THESE PLANS have been examined for compliance with the Ontario Building Code Requirements. A Building Permit is in Order to issue subject to any changes noted under the condition that the building will be constructed in accordance with the code

2070
CORNER LOT
GARDEN 11-065
ELEVATION 1
A1 PACKAGE
O.REG. 332/12

TITLE SHEET
BARLASSINA CONSTRUCTION
CITY OF CAMBRIDGE

FIRST FLOOR PLAN EL-1
BARLASSINA CONSTRUCTION
CITY OF CAMBRIDGE

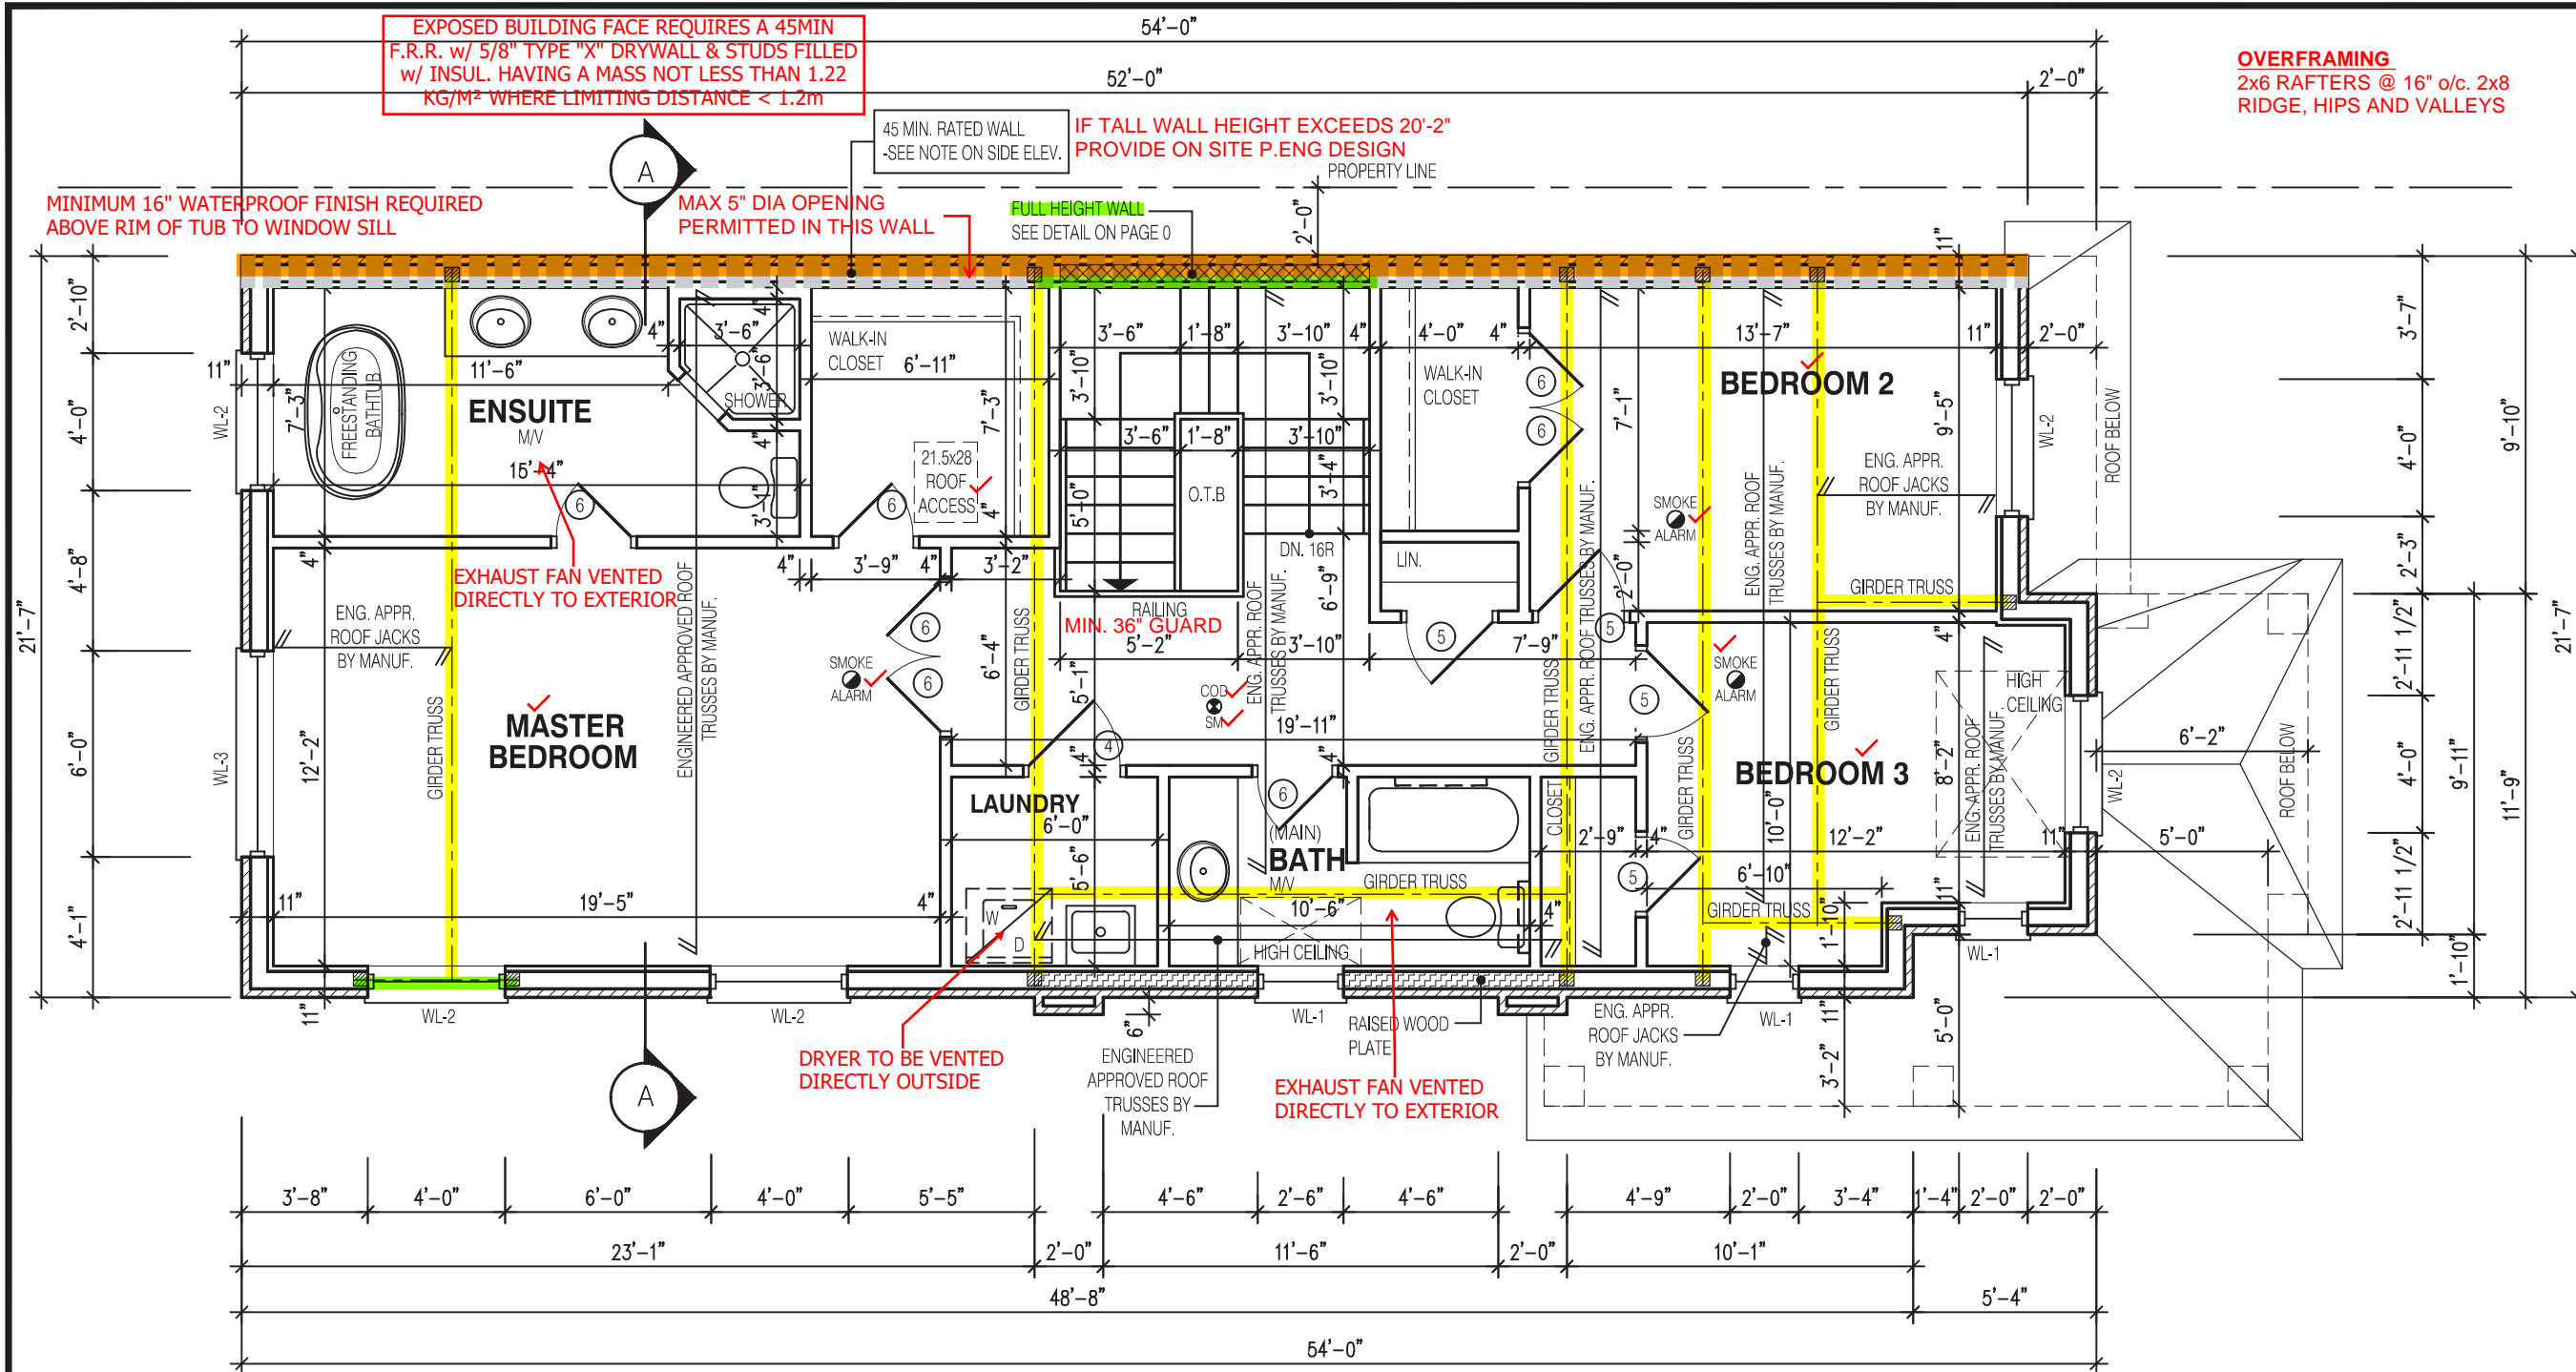
A LANDING IS REQUIRED AT THE ENTRANCE FROM AN ATTACHED GARAGE WHEN THERE ARE MORE THAN 3 RISERS BETWEEN THE GARAGE FLOOR AND THE INTERIOR FLOOR LEVELS IN ACCORDANCE WITH 9.8.6.2.(3)(a). GUARDS CONFORMING TO O.B.C. 9.8.8. & SB-7 ARE REQUIRED WHEN LANDING EXCEEDS 24" ABOVE GARAGE FLOOR

*TRACE ALL POINT LOADS THROUGH FLOOR SYSTEM TO SOLID BEARING BELOW

EXPOSED BUILDING FACE REQUIRES A 45MIN F.R.R. w/ 5/8" TYPE "X" DRYWALL & STUDS FILLED w/ INSUL. HAVING A MASS NOT LESS THAN 1.22 KG/M² WHERE LIMITING DISTANCE < 1.2m

FRONT ELEVATION 1

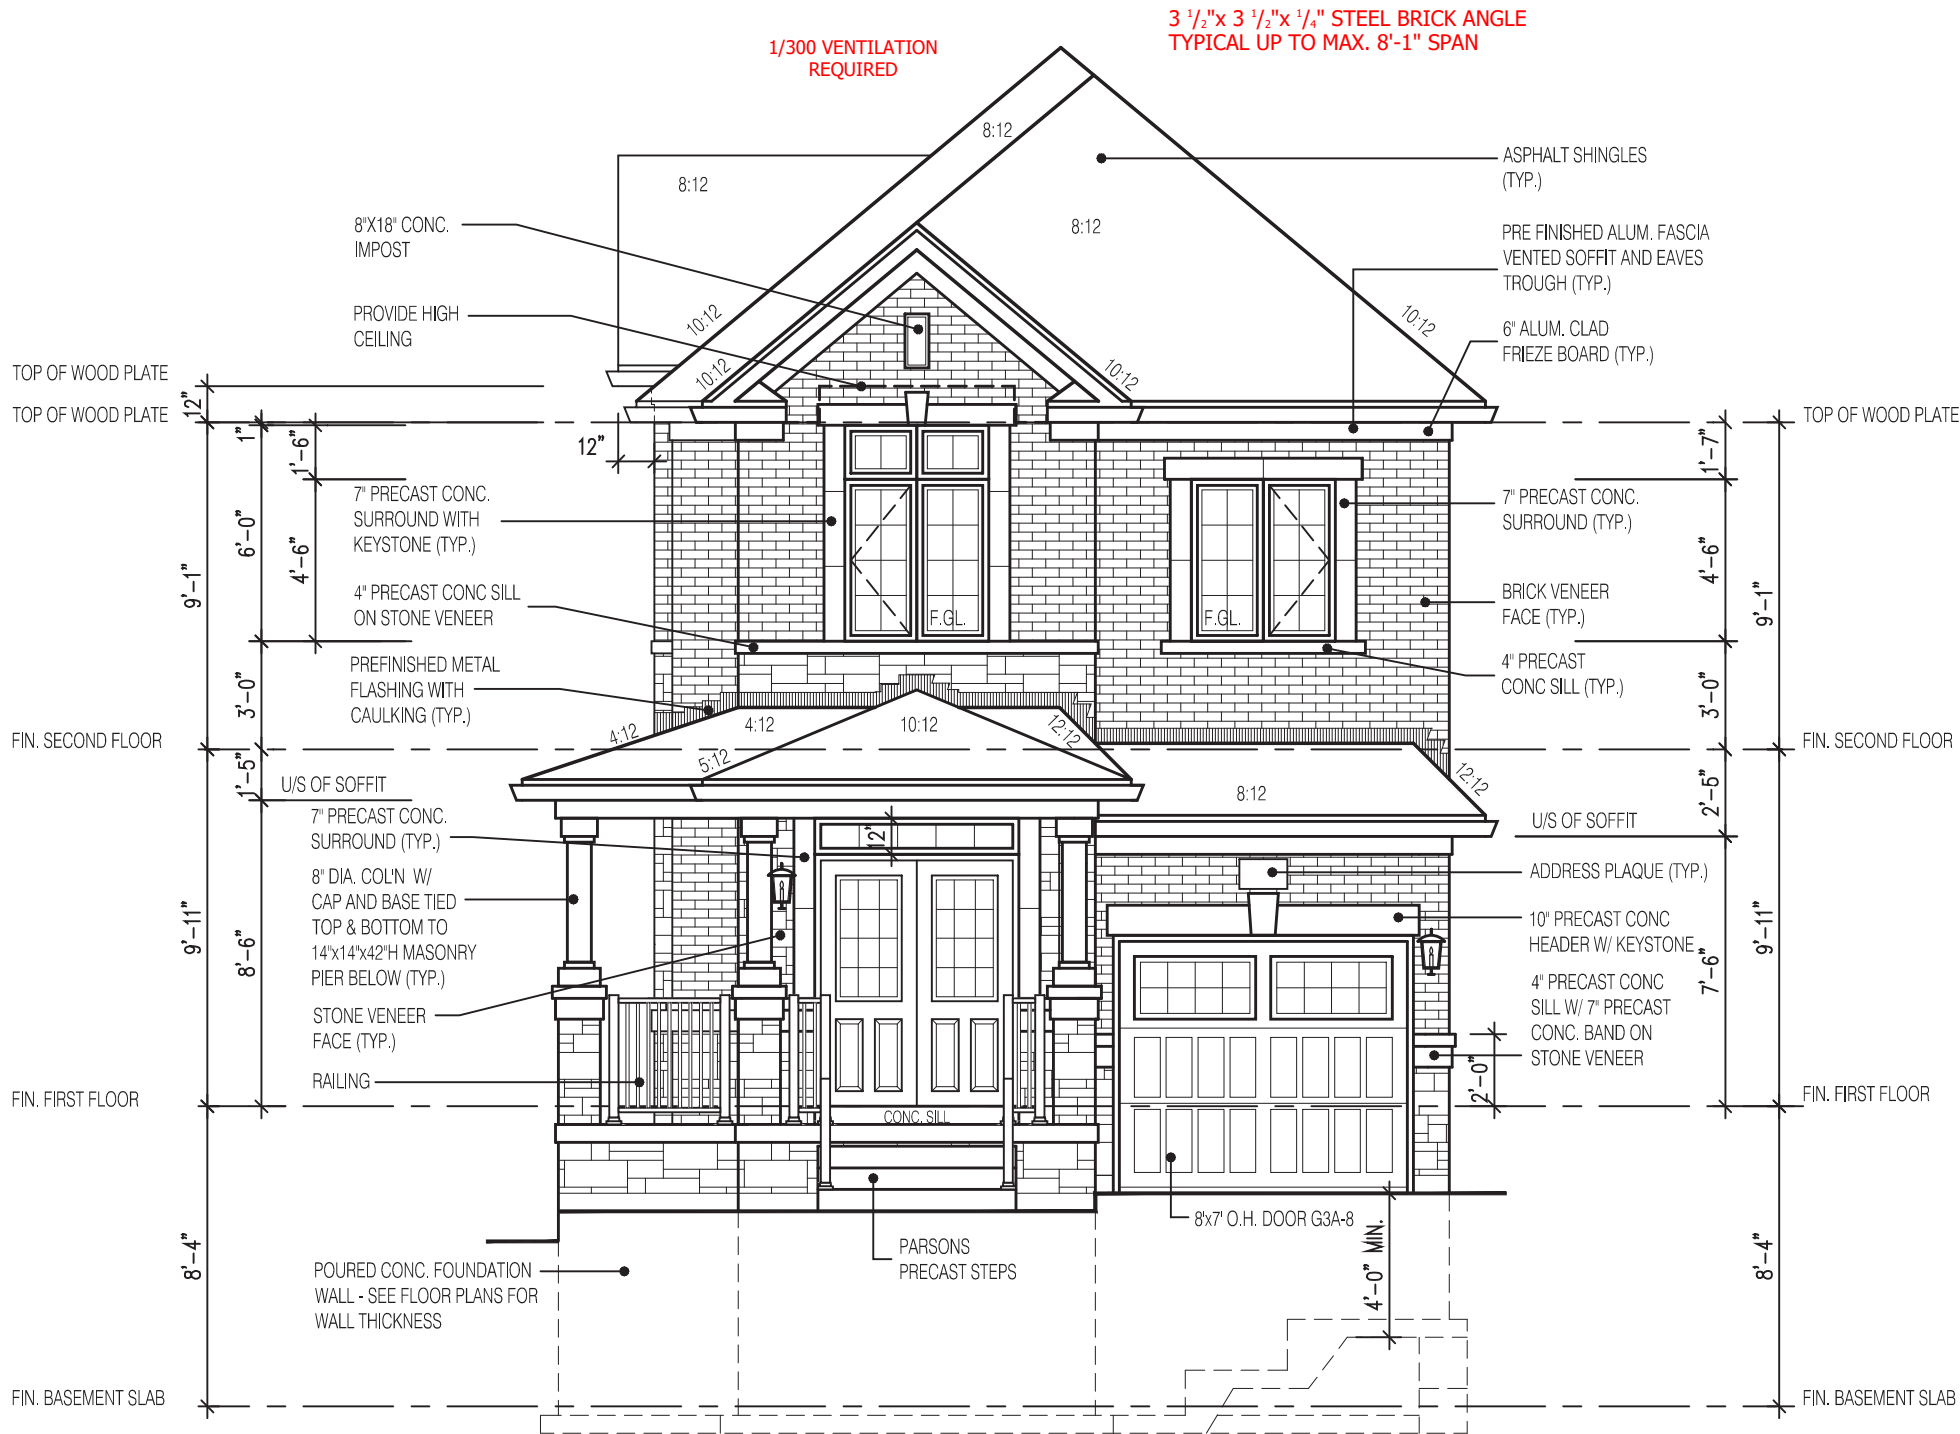
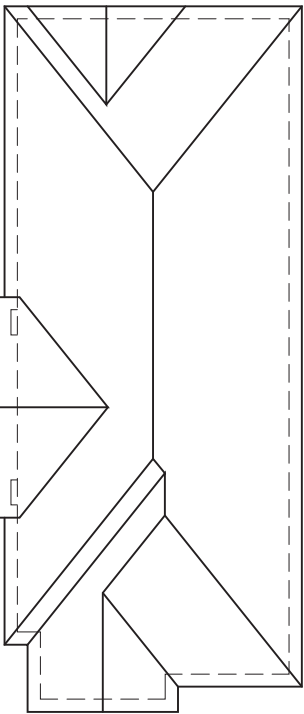
A LIGHT IS REQUIRED AT ALL ENTRANCES TO A SINGLE FAMILY DWELLING

STEP FOOTINGS. MAX 24" RISE, MIN 24" RUN

GUARDS CONFORMING TO O.B.C. 9.8.8. & SB-7 ARE REQUIRED FOR PORCHES EXCEEDING 24" ABOVE GRADE.

ENSURE P.ENG STAMPED RAILING DOCUMENTATION AND ATTACHMENT DETAILS ARE AVAILABLE FOR REVIEW BY THE INSPECTOR

EXTERIOR CONCRETE STAIRS w/ MORE THAN 2 RISERS TO MEET THE REQUIREMENTS OF 9.8.9.2.(1)

FLANKAGE ELEVATION 1

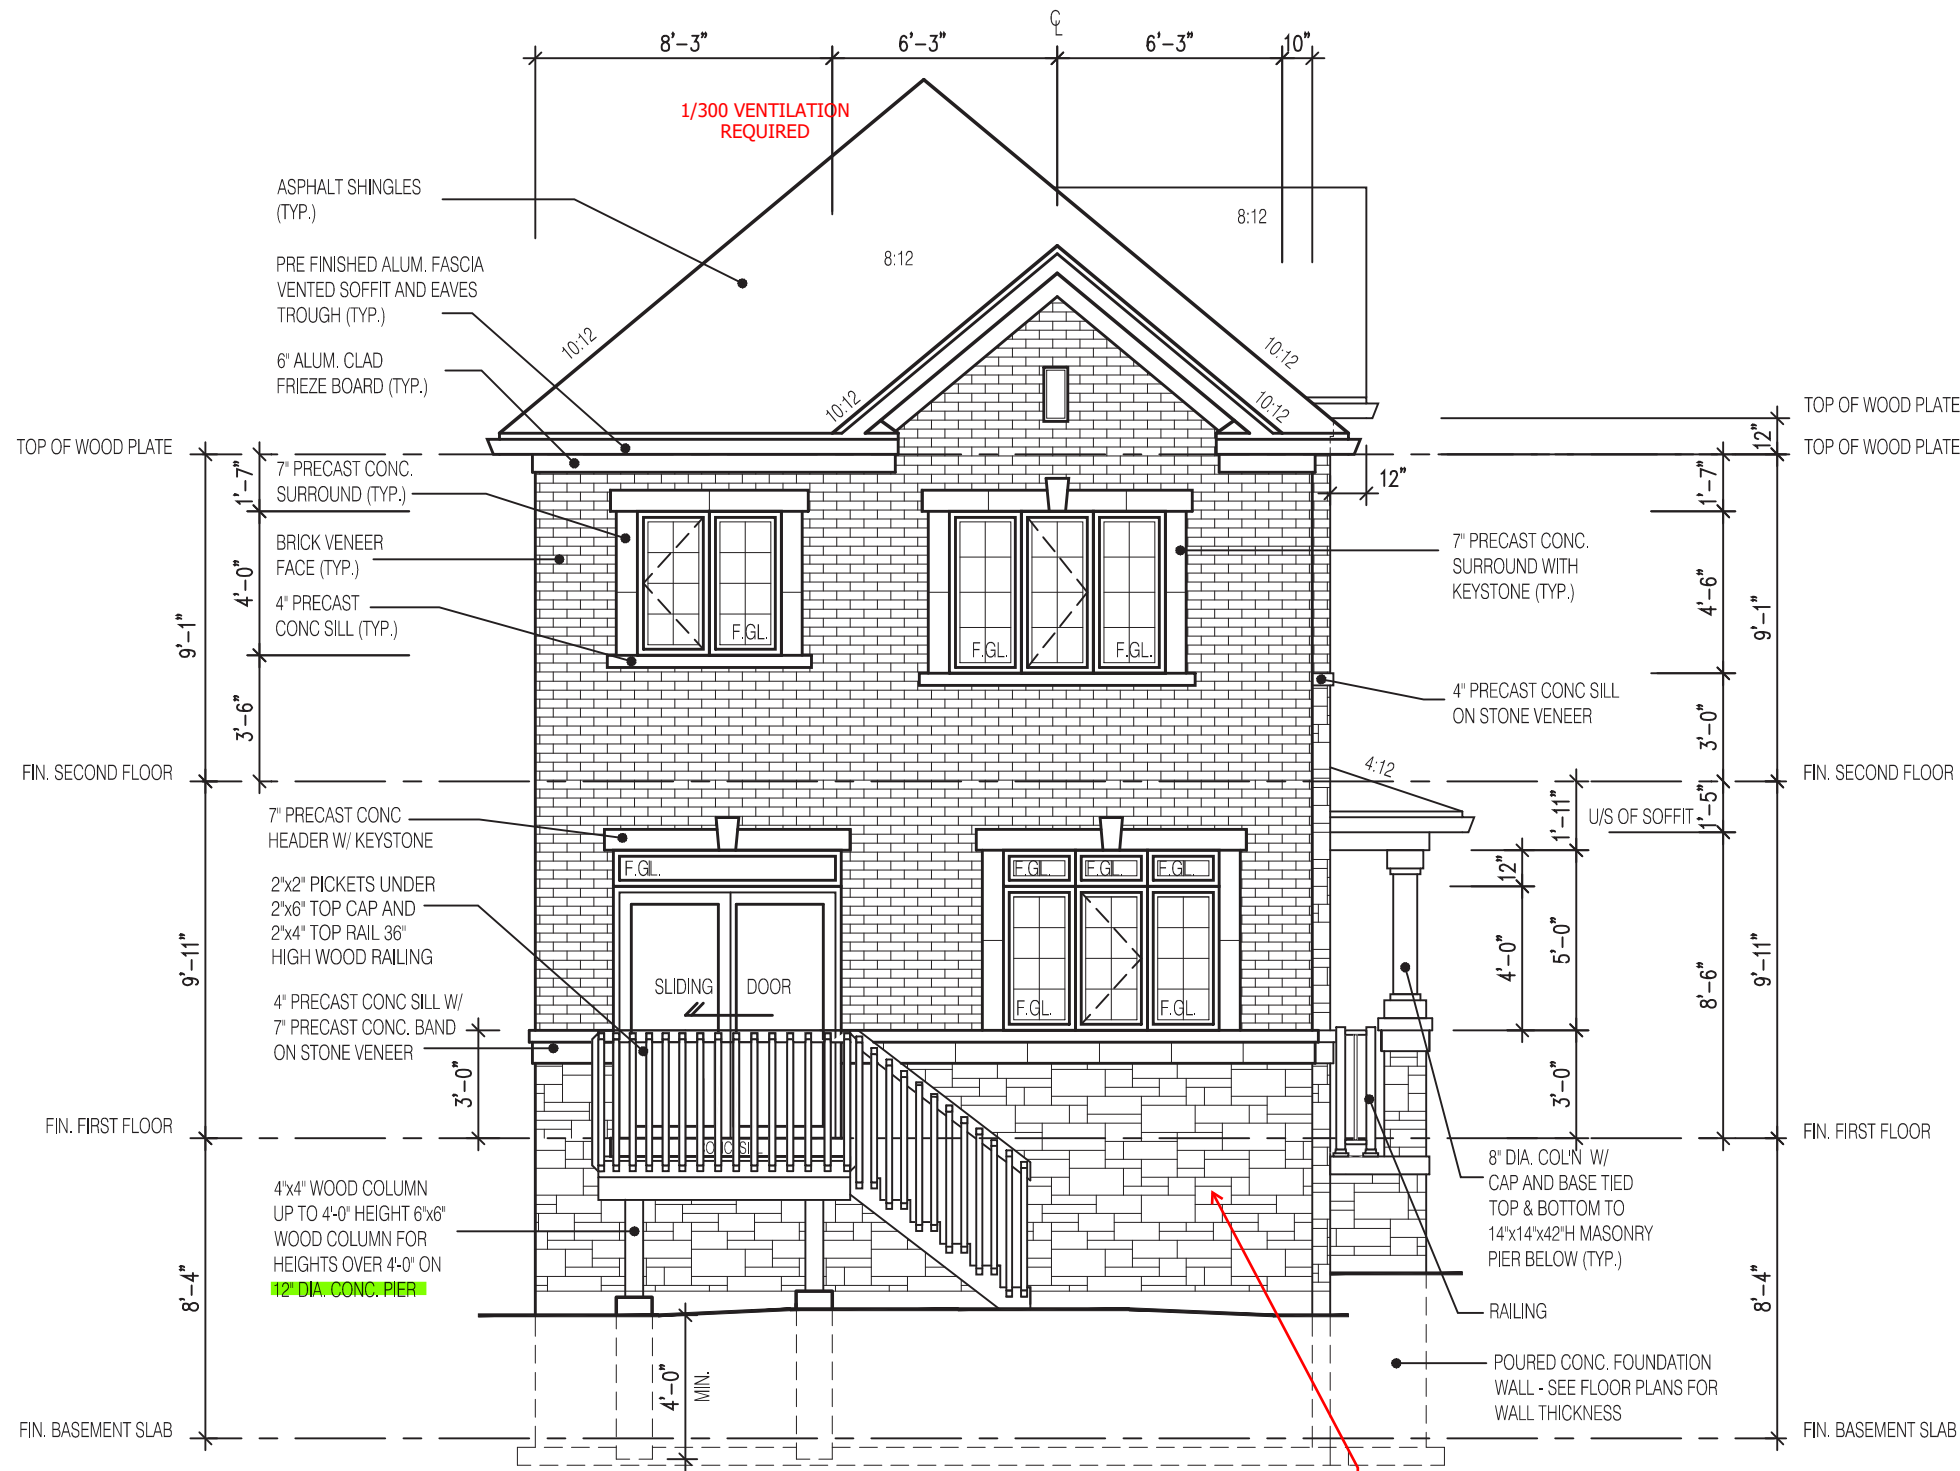
UPO OK, FACES STREET

NOTE:
WHEN VENEER CUT IS GREATER THAN 26" A 10" POURED CONC. FOUNDATION WALL IS REQUIRED.
(FOUNDATION PLAN TO BE REVIEWED IN CONJUNCTION WITH SITE PLAN)
